breakaway creek inc.

Retro '64 Layout

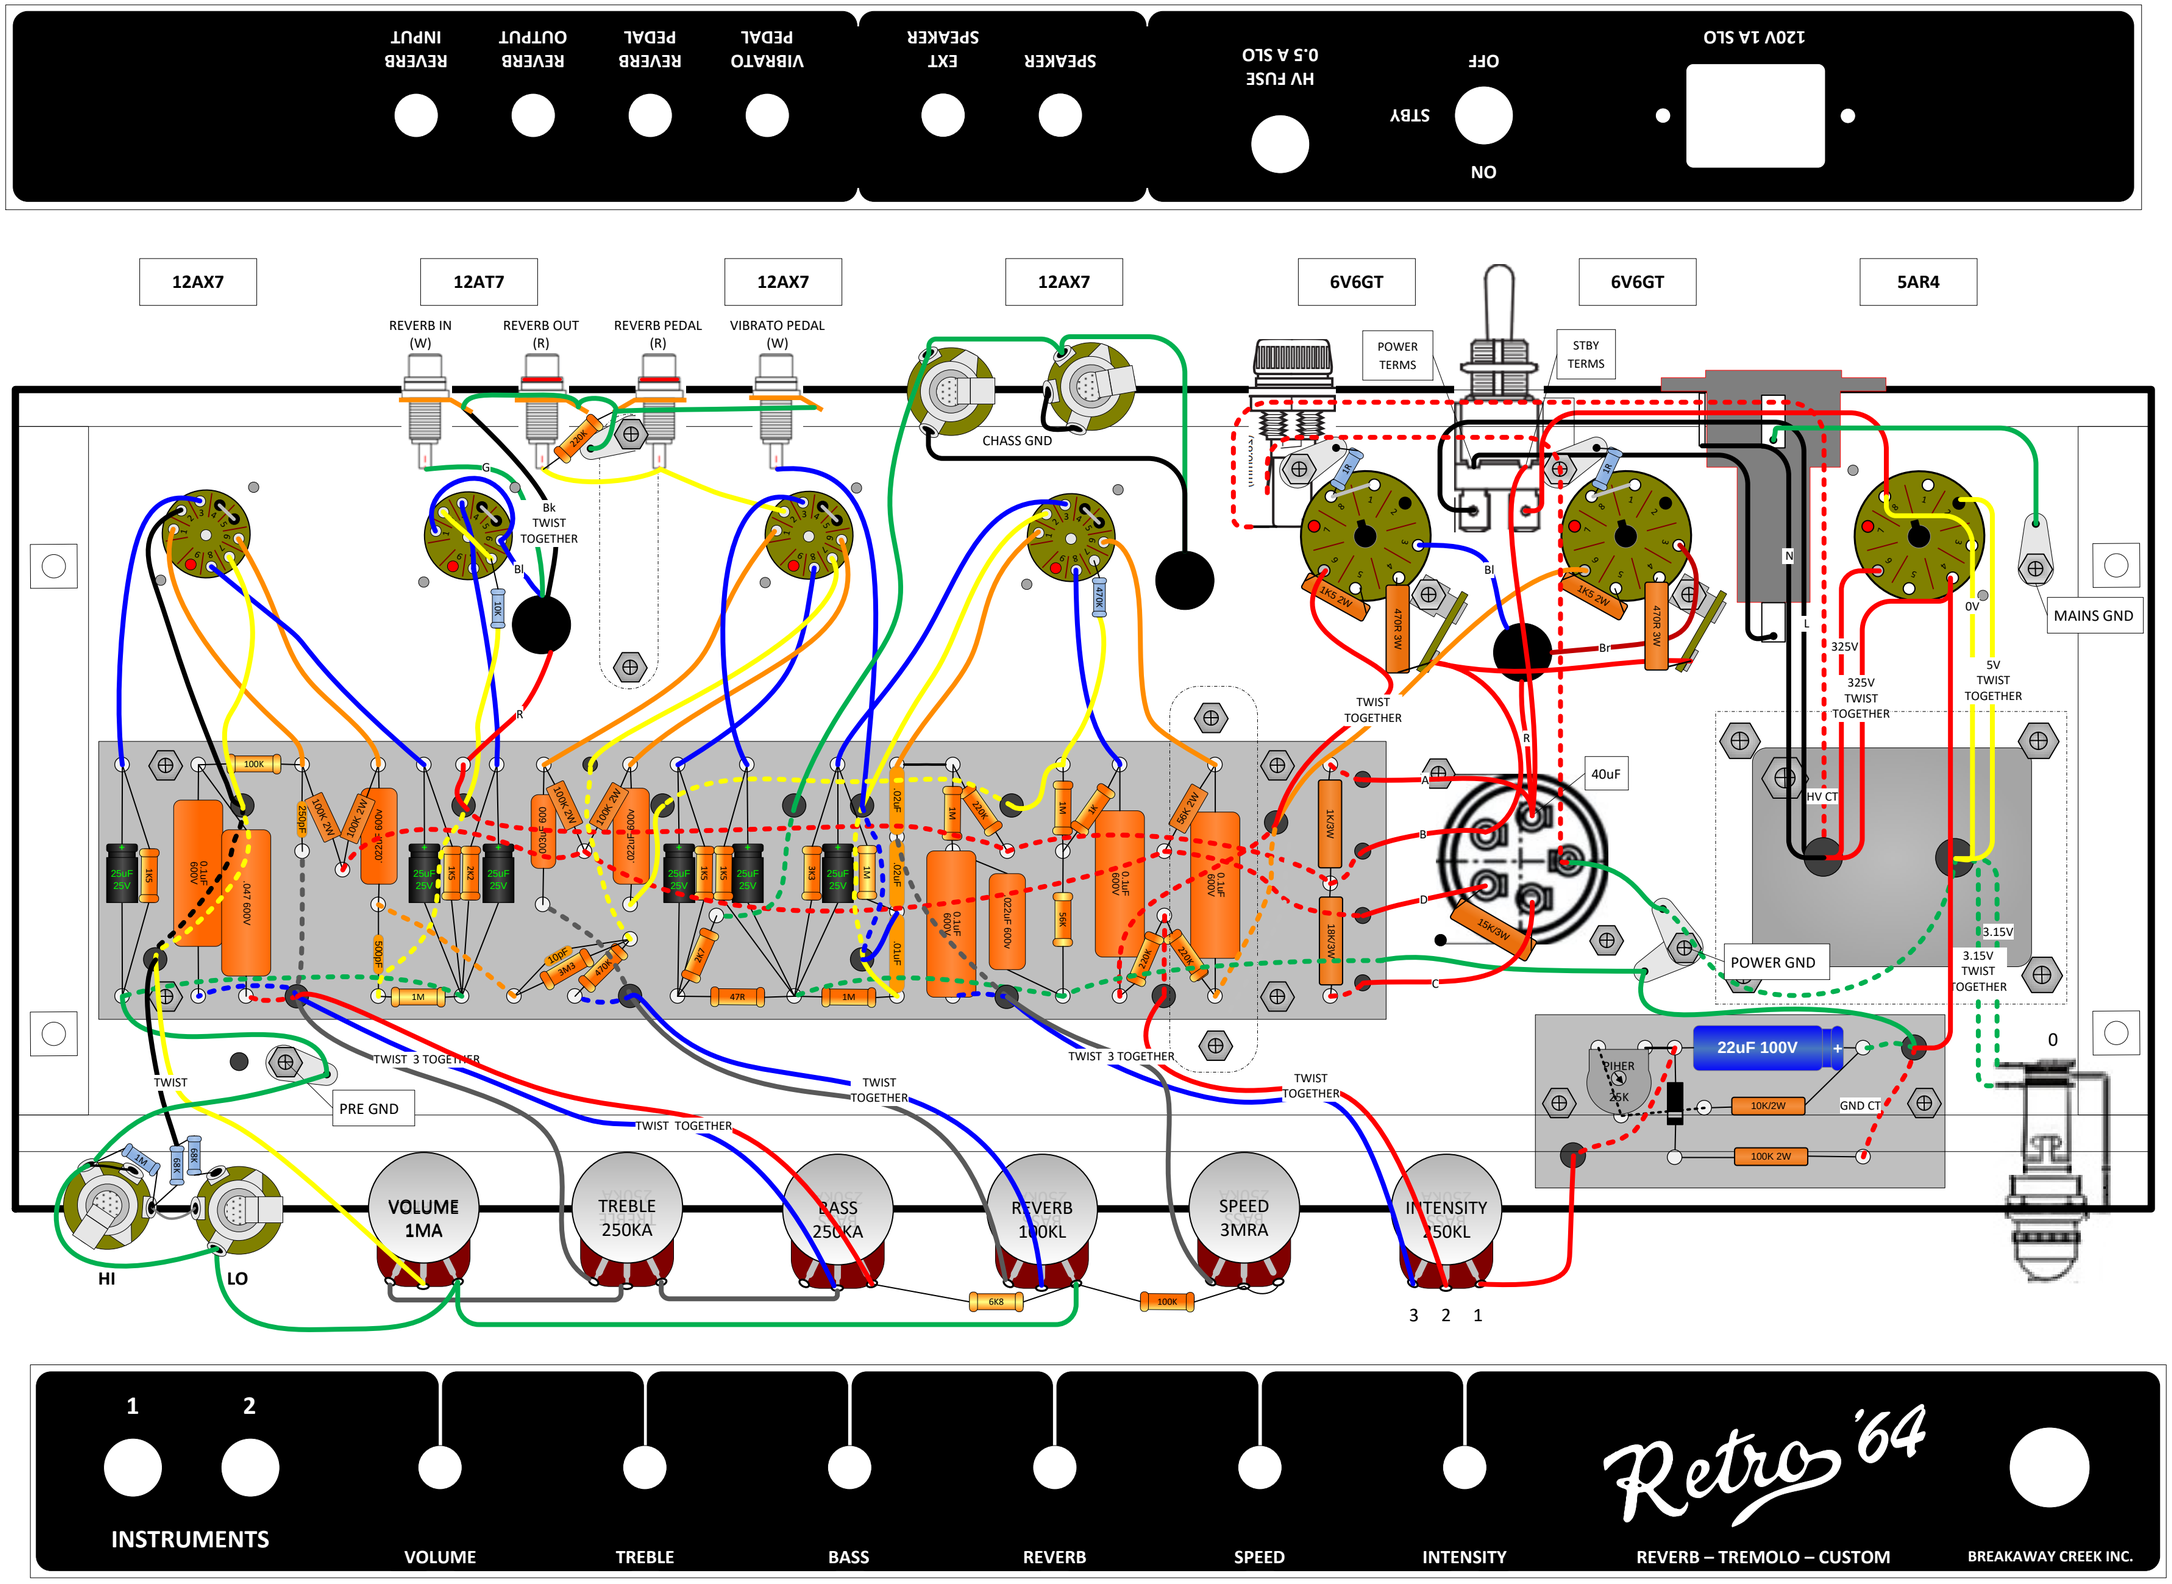
1 initial release
2 corrected power switch connections
3 added twisting notation
4 corrected progressive power switch conns.
5 corrected output jack wiring
6 mod. rev. sock grid wiring & added 10K to V2 grid
7 corrected .02 osc. cap to speed control wiring
8 updated board and panels layout
9 corrected bias, bass pot & input jack layout, updated RCA jack install; changed wiring of HV fuse
10 changed bias filter cap to 22uF; mod. Rev I/O jack colours
11 reversed 3 pos power switch labels
